ENGINE - GENERAL - PROVIDE BOLTS OF INCREASED LENGTH AT CLIPPING POINTS CP0577, CP0560
AND CP0537 - CATEGORY CODE 5 - MOD.ENG-72-0052

V2500-ENG-72-0052

View showing clipping points CP0537, 0560 and 0577
Fig.1

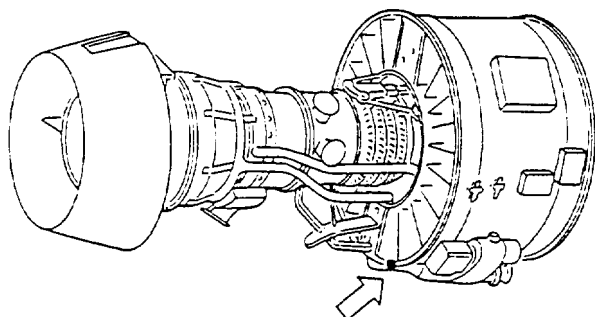
The bolts used at clipping points CP0577, CP0560 and CP0537 may not be of sufficient length. This could cause a looseness of the clipping nuts.

The existing bolts at CP0577, CP0560 and CP0537 may not protrude an acceptable protrusion amount.

(a) The bolts at CP0577, CP0560 and CP0537 have been changed to increase the bolt length (See Figure 1).

- (1) At CP0577 and CP0560, remove each 4W0106, Bolt, by the procedure given in the Engine Manual (Refer to Figure 1, and Engine Manual, 72-00-32, LP Compressor/Intermediate Case Module - Removal, TASK 72-00-32-020-003).
- (2) At CP0537, remove 4W0115, Bolt, by the procedures given in the Engine Manual (Refer to Figure 1 and the Engine Manual, 72-00-32, LP Compressor/Intermediate Case Module - Removal, TASK 72-00-32-020-003).
- (3) At CP0577 and CP0560, install each new 4W0108, Bolt, by the procedures given in the Engine Manual (Refer to Figure 1 and the Engine Manual, 72-00-32, LP Compressor/Intermediate Case Module - Installation, TASK 72-00-32-420-003).
- (4) At CP0537, install new 4W0116, Bolt, by the procedures given in the Engine Manual (Refer to Figure 1 and the Engine Manual, 72-00-32, LP Compressor/Intermediate Case Module - Installation, TASK 72-0032-430-003).

CP0560
REMOVE 4W0106 BOLT
AND
INSTALL 4W0108 BOLT

CP0537
REMOVE 4W0115 BOLT
AND
INSTALL 4W0116 BOLT

CP0577
REMOVE 4W0106 BOLT
AND
INSTALL 4W0108 BOLT
